Arizona Mining Reform Coalition – Access Fund –
Concerned Citizens & Retired Miners Coalition –Earthworks – Sierra Club

May 31, 2022

***Re: Comments and Objections to ADEQ's Renewal of the Resolution Copper Mining
AZPDES Permit No. AZ0020389 (LTF No. 90471)***

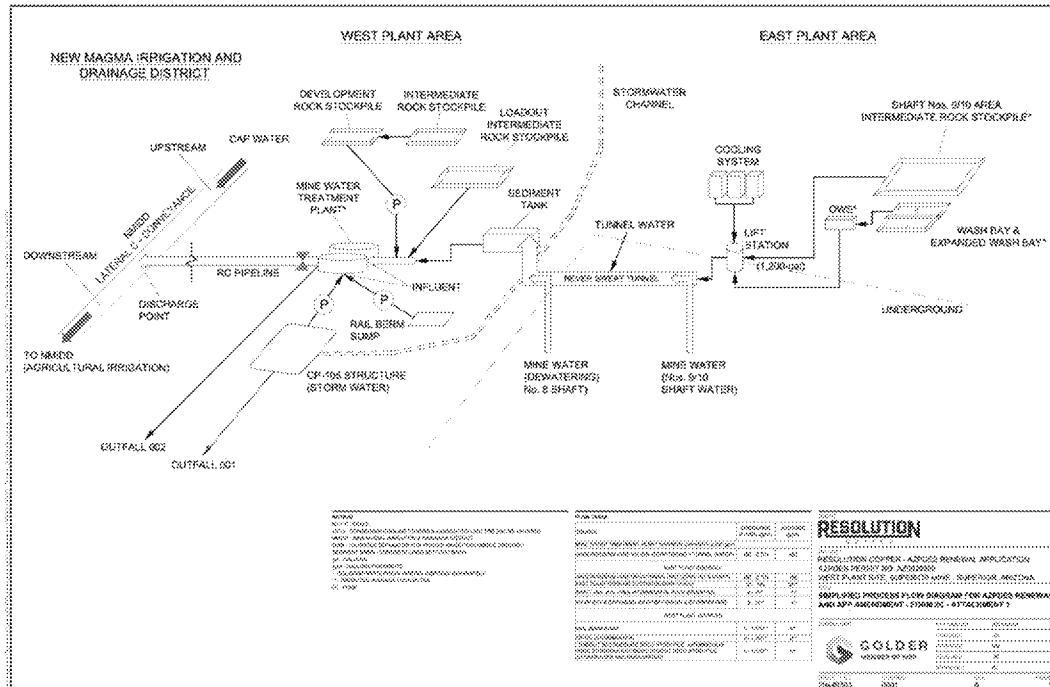
The Process Flow Diagram (shown below) and Site Drainage Maps attached to the AZPDES Renewal Application⁸ indicate that stormwater from across the West Plant site drains to and is

collected in Collection Pond No. 105 (CP-105, formerly “Indian Pond”) where it can then be discharged through Outfall 001. The West Plant Site is located north of Highway 60 in Superior, just north of Queen Creek, and drains south towards Queen Creek.

The West Plant site contains a significant amount of toxic pollutants in the area produced by smelting activities, emissions, tailings ponds, and other mine waste from previous mining activities. There are multiple sites located across the West Plant site which have the potential to convey pollutants and other constituents of concern into Queen Creek via discharge of stormwater at Outfall 001.

The East Plant Site is east of the Town of Superior. The Process Flow Diagram (shown on the prior page) indicates that waters from various sources at the East Plant Site are collected and transported to the Water Treatment Plant at the West Plant Site through the Never Sweat Tunnel.

ADEQ should require that feed water quality data from these “various combined sources” at the East Plant Site be collected and analyzed for purposes of this permit. Data on the inflow into MWTP is essential to the ongoing functionality of the MWTP. ADEQ’s failure to require this information is inconsistent with their mission and obligations in administering the Clean Water Act. For all of those reasons, the permit renewal application is administratively incomplete.

Figure 5: Modeling Basins that have Water Quality Data

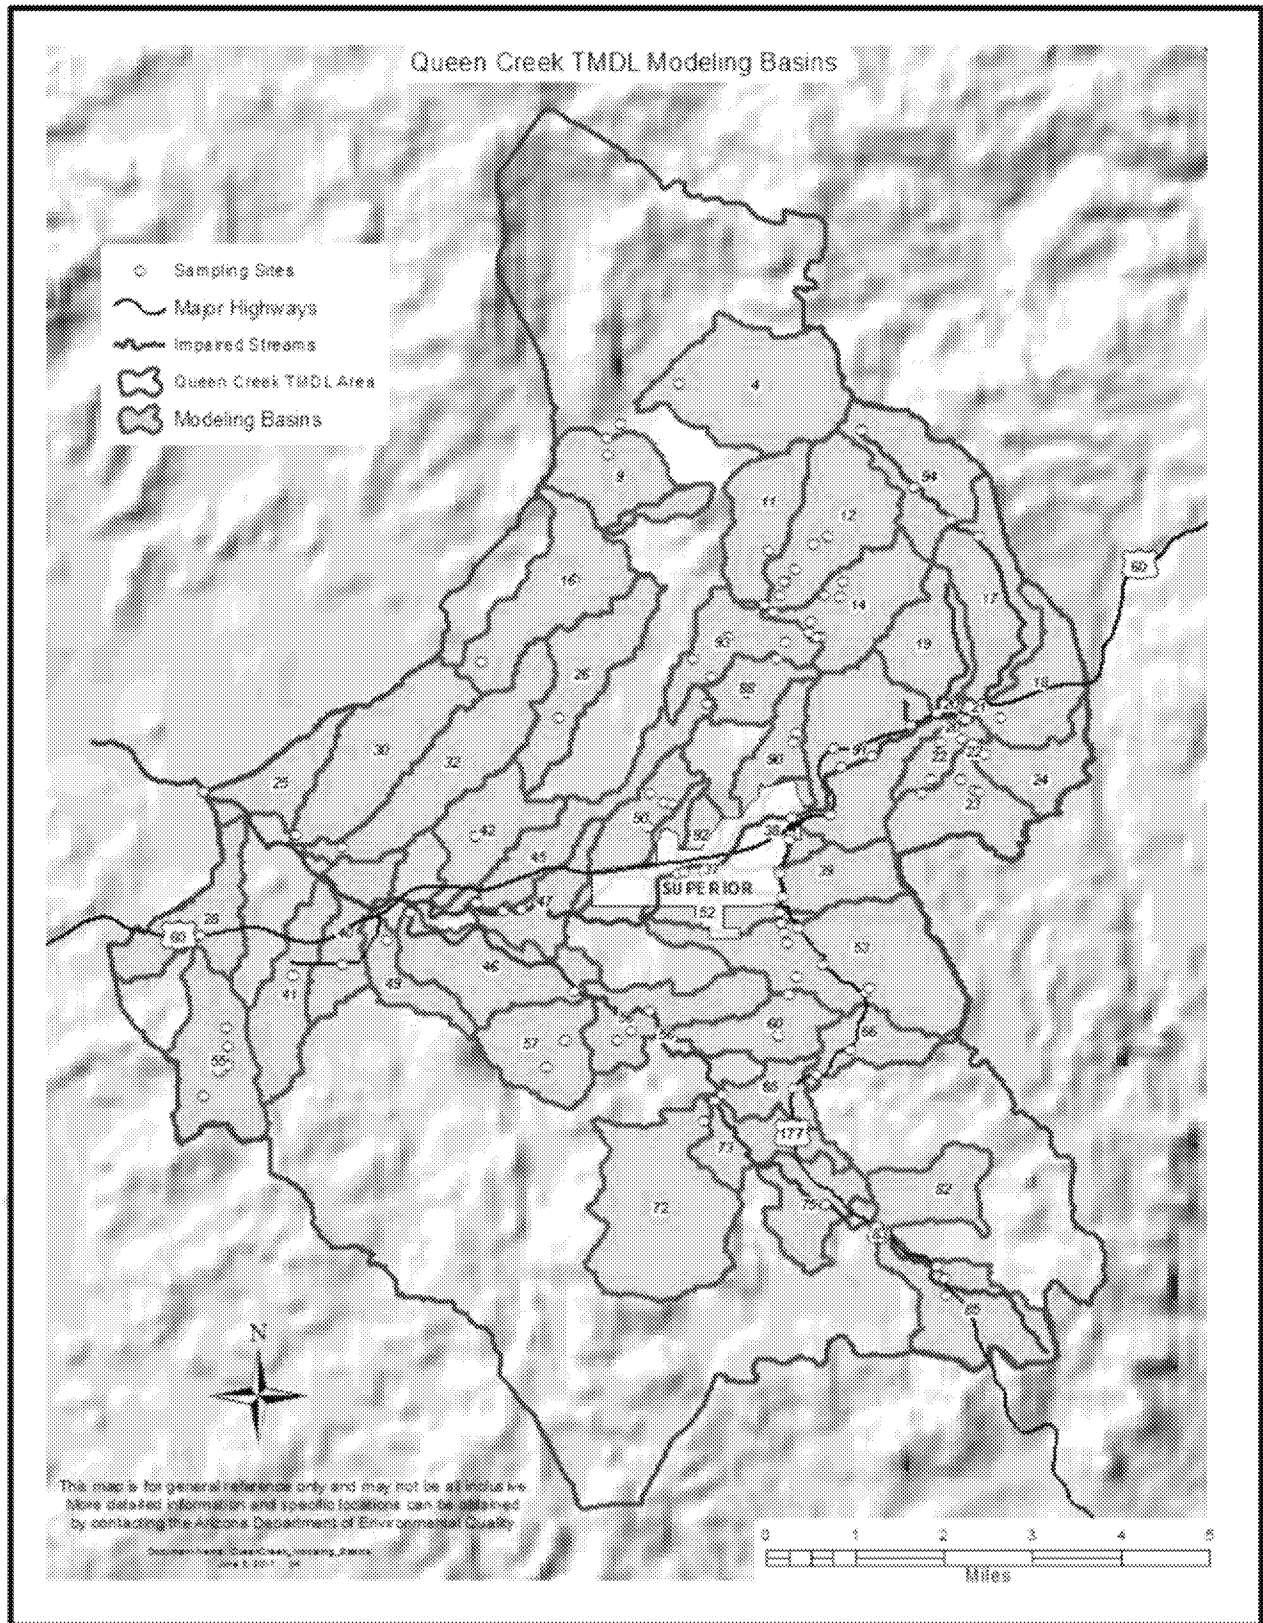
Figure 5 of the draft shows that ADEQ did not include a number of the sub-basins in their modeling. Since some of the sub-basins not used in the modeling are quite large, the modeling exercise itself is fatally flawed. Why are some sub-basins not used? What rationale was used to choose the basins used? How were the “representative” basins chosen to assure that they are truly representative?

Figure 6: Observed vs Simulated Flows in Modeling Basin 46- Arnett Creek

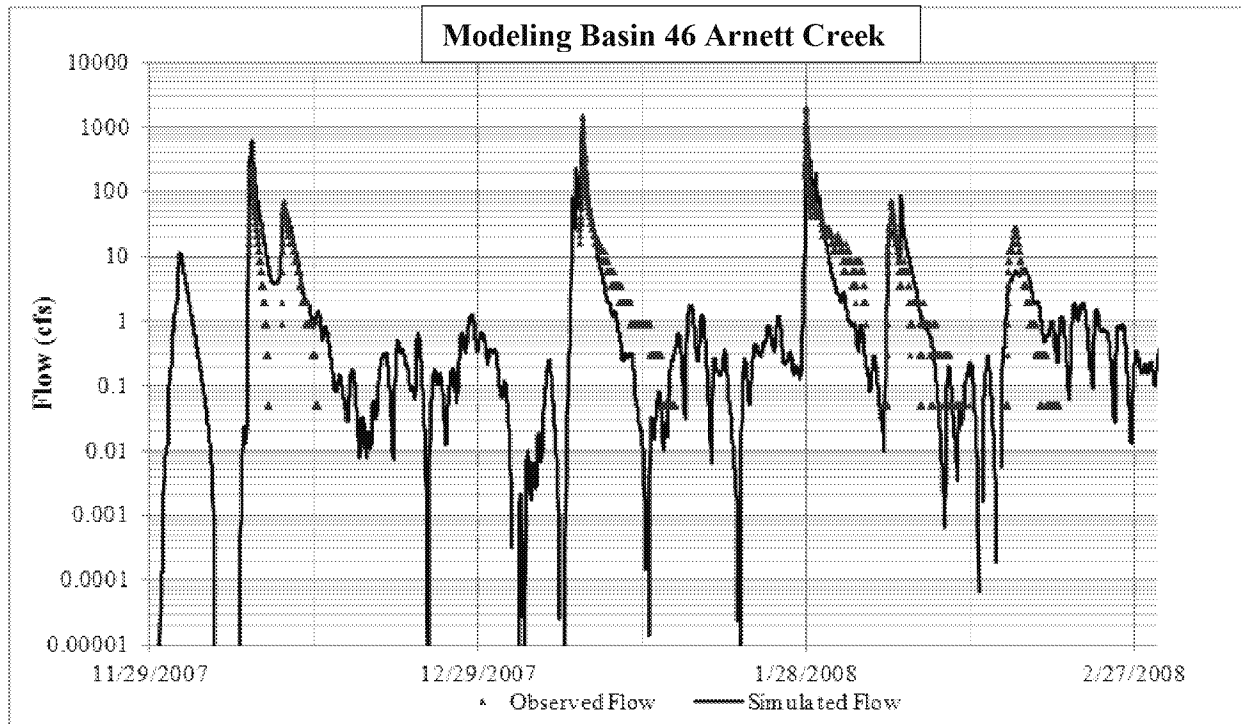
Figure 6 does not support the draft reports conclusion that actual data matches simulated modeling. Was this a cherry-picked graph or do other sub-basins also show any kind of correlation? To us, Figure 6 does not show an acceptable visual agreement between observed and simulated flows.

Figure 7: Observed vs Simulated Dissolved Copper in Modeling Basin 46 - Arnett Creek

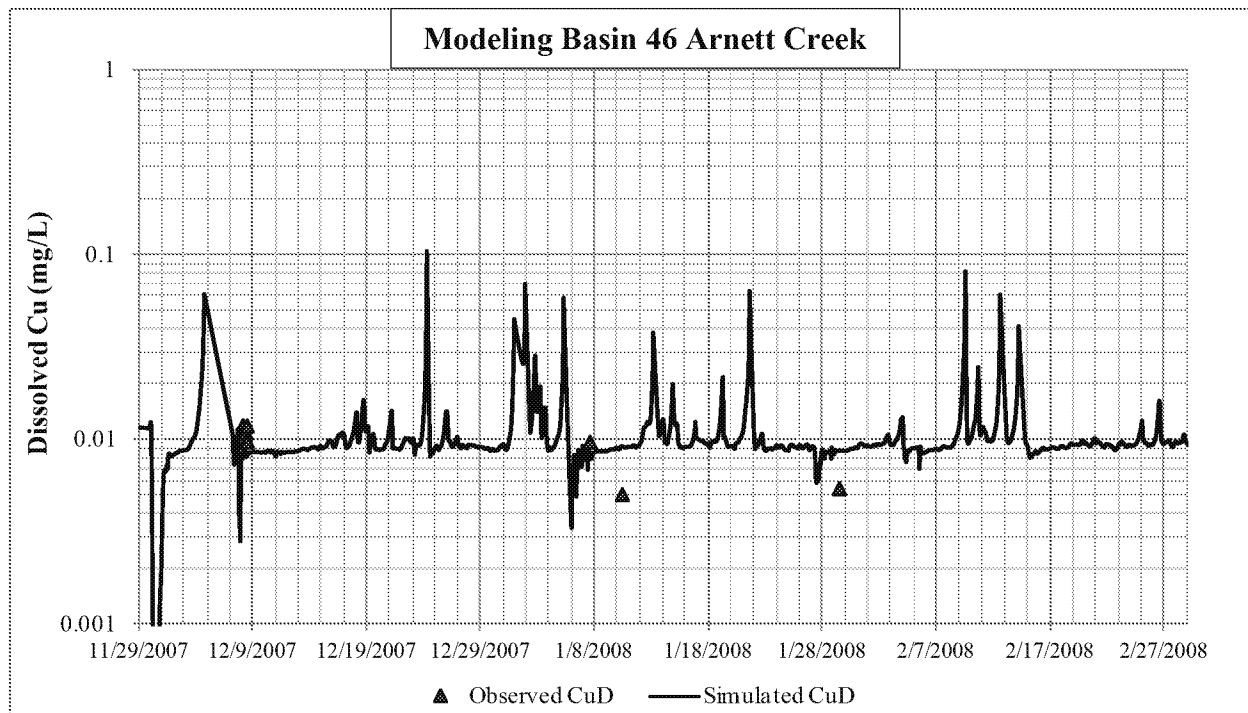
As with Figure 6, there is simply not enough data in Figure 7 to support ADEQ’s conclusions.
